Salinas Valley Water Coalition

22 October 2025

Re: Comments on April 2025 Salinas Valley Historical Benefits Analysis Update and May 29, 2025,
Draft Interlake Tunnel and San Antonio Spillway Modification Assessment Engineers Report

To: Nancy Isakson, President, Salinas Valley Water Coalition
CC: Eric Robinson, Kronick Moskovitz Tiedemann & Girard
From: Dwight L. Smith, PG, CHg, Principal Hydrogeologist
Date: September 2, 2025
Subject: **Technical Review Comments on the MCWRA Historical Benefits Analysis and Draft Interlake Tunnel Engineers Report**

Figure 1-6 (HBA, 1998) of average increase in water levels elevations resulting from reservoir options from the 1998 HBA modeling.

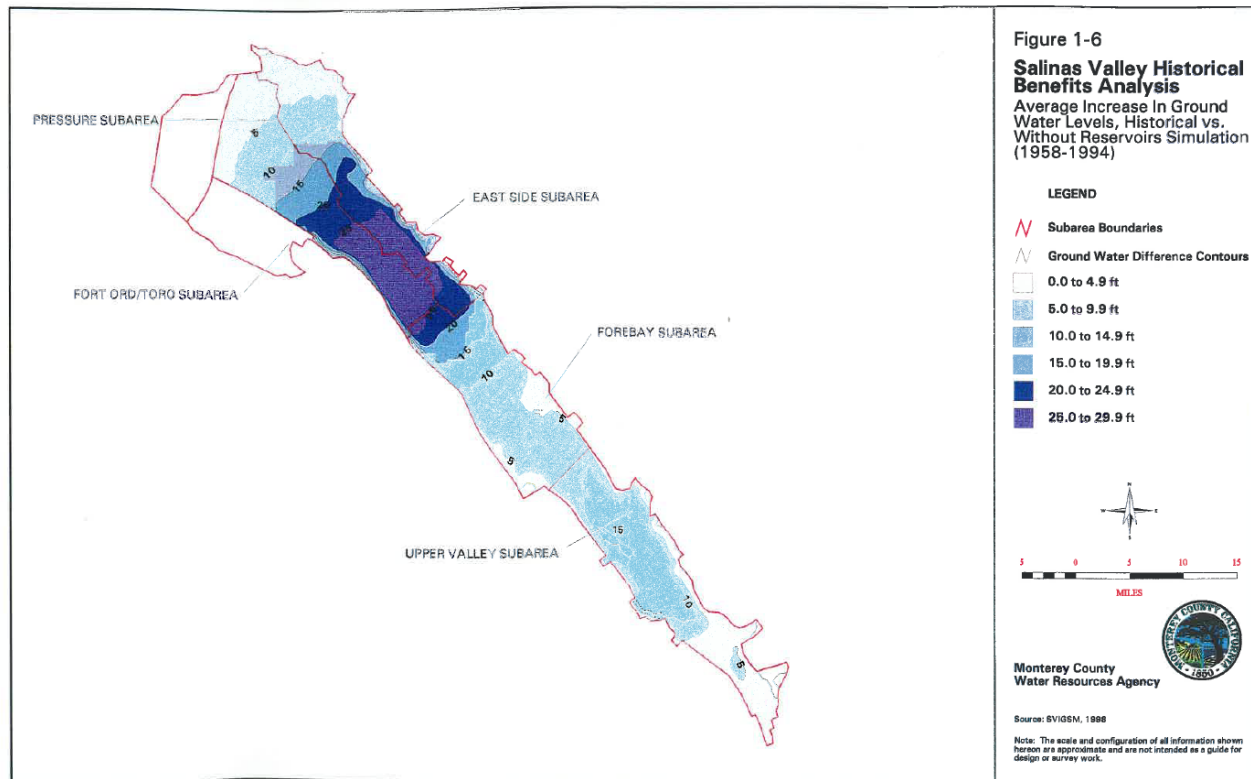
The drain issue in the 2023 provisional version of the SVIHM used for the HBA Update has particular relevance to objectives of the modeling and the HBA Update, because the analysis relies heavily on groundwater elevation differences simulated by the model with and without the reservoirs along with CSIP and SVWP to quantify benefits. I believe that the use of the SVIHM model version with the unacceptable use of “fictitious” drains extensively over the model domain to resolve or mask water budget errors or water elevation errors in the model renders the simulated scenario differences useless for the intended purpose. For note, one of the largest water budget parameter changes observed in the HBA Update modeling is the change in drain outflows (see Table 3-2 from the HBA Update, copy provided below, highlight added)

The unacceptable use of the drains in the SVIHM model version used for the HBA Update analysis is also a likely explanatory reason for the noticeably different model outcomes for predicted water level elevation changes with and without the reservoirs in the 1998 versus 2025 HBA modeling. Predicted groundwater elevation changes as a result of historical reservoir operations were notable in the southern Pressure Subbasin and north Forebay Subbasin in the 1998 SVIGSM modeling, with average water level elevation increases of 10-25 ft (see Figure 1-6 from the 1998 HBA report, included below). Over most of the Salinas Valley, the 1998 modeling indicated a 5-10 ft average water level increase. By comparison, the 2025 HBA Update modeling predicts essentially no average annual water level increase as a result of the reservoirs, with only modest increase directly along the river, and more substantial water level increases in the northern Pressure subbasin as a direct result of CSIP/SRDF. In review of available historical water level elevation data, it appears that a historical rise in water level elevations post-reservoirs (1958 for Nacimiento) as represented in the 1998 modeling is supported by the data, but perhaps of a more modest magnitude of approximately 5-15 ft (reference is made to hydrographs of water level elevations for 1948-1994 in the Appendix A to the HBA, Montgomery Watson, 1998).

The lack of predicted water level elevation responses from the reservoir operations and inconsistency with the prior body of work from the 1998 HBA modeling, which was a significantly peer reviewed effort, should have led to questioning of the validity of the results being observed in the HBA Updated modeling.
